hp Model 4800A Vector Impedance Meter  
serials prefixed 805 and below

Thermistor A17R14 Replacement  
hp Modification Kit 04800-61043

Modification Kit 04800-61043 is a replacement kit for thermistor 0837-0045 in the hp Model 4800A Vector Impedance Meter, serials prefixed 805 and below. Later instruments do not use the thermistor.

Figure 1. Feedthru Location - A17 Board

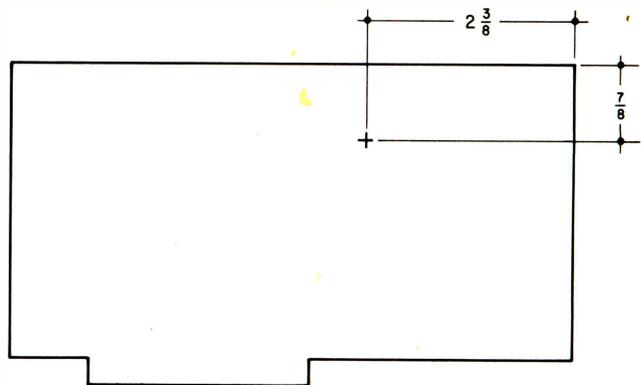
1. Remove power from instrument.
2. Remove R1, 2.87 K resistor mounted on TEST-OPERATE Switch, S1. (located between XA14 and XA16).
3. Remove A17 (Stock No. 04800-61002) from the instrument. Remove thermistors R14 and R15 including shock absorber and strap.
4. Replace R13 with jumper.
5. Drill ( $7/32''$ ) (5.5 mm.) hole in location shown in Figure 1. **CAUTION:** Start with a small size drill and enlarge hole in steps to prevent drill from seizing.
6. Install press-fit feedthru.

Figure 2. A17 After Modification

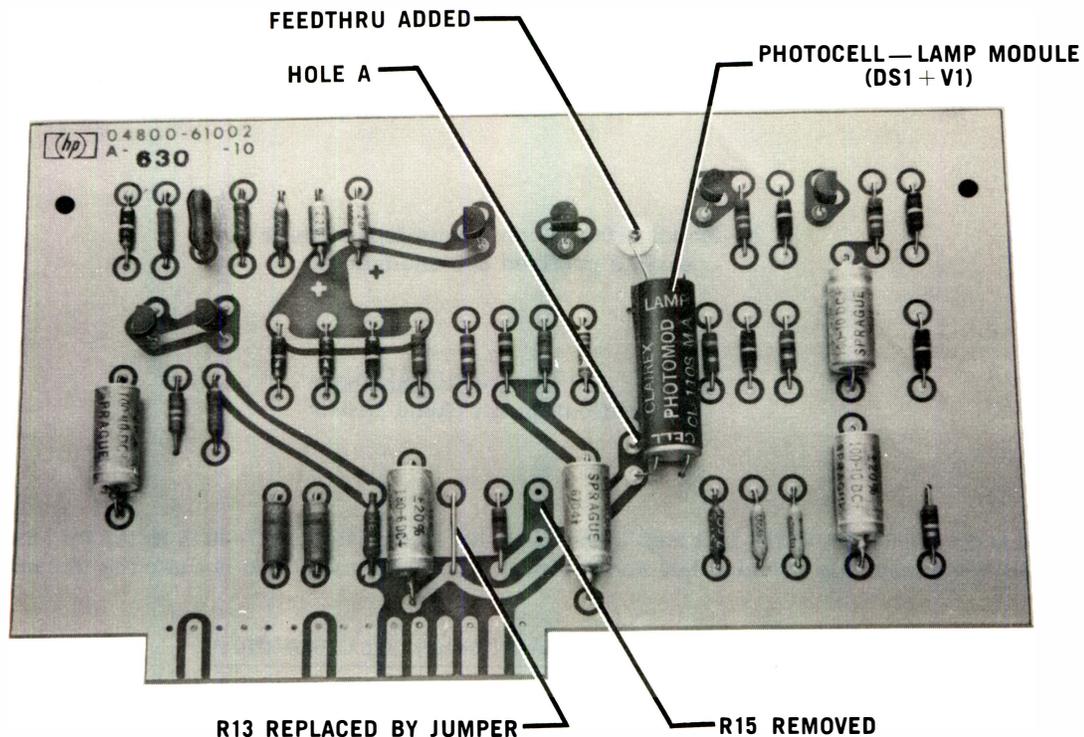
7. Connect short wire from hole "A" (Figure 2) to feedthru on back side of board.

8. Install photocell-lamp module, DS1 + V1. Cell end of module is mounted closest to the plug-in connections.

Figure 2 shows A17 after modification.

Figure 3. Feedthru Location - A14 Board

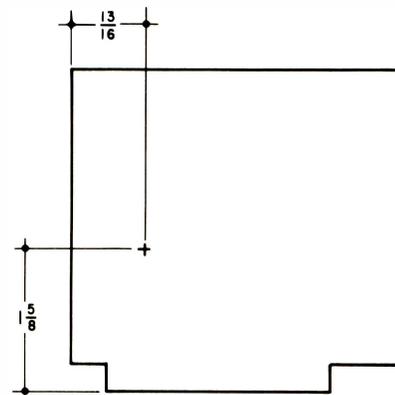
12. Drill ( $7/32''$ ) (5.5 mm.) hole in location shown in Figure 3. As in step 4 above, enlarge hole in steps to final size.

13. Install feedthru; clip lead off back of board.

Figure 4. A14 After Modification

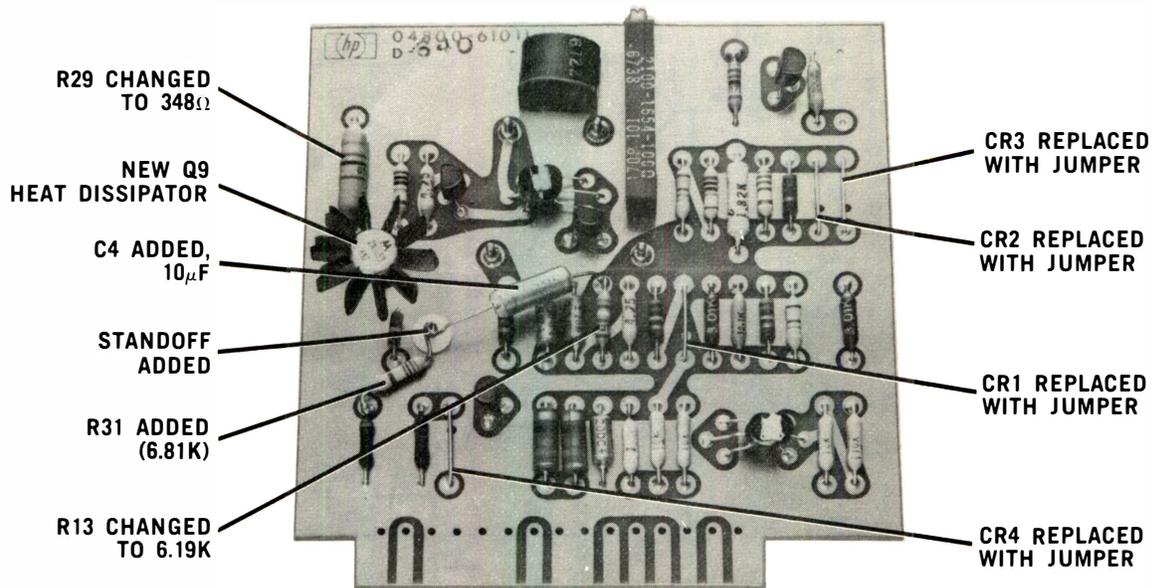
14. Replace R13 with 6.19 K $\Omega$ .

15. Replace R29 with 348  $\Omega$ .

16. Connect R31, 6.81 K $\Omega$  from feedthru to R30. Tack-solder to R30.

Figure 4 shows A14 after modification.

17. Connect C4, 10  $\mu$ F from standoff to R13. Note polarity: + lead to feedthru.

18. Place heat dissipator on new Q9; install on board with  $1/2''$  leads. Leads must be long enough to allow moving Q9 and heat dissipator away from chassis. Q9 case must not be grounded; it is electrically connected to the collector.
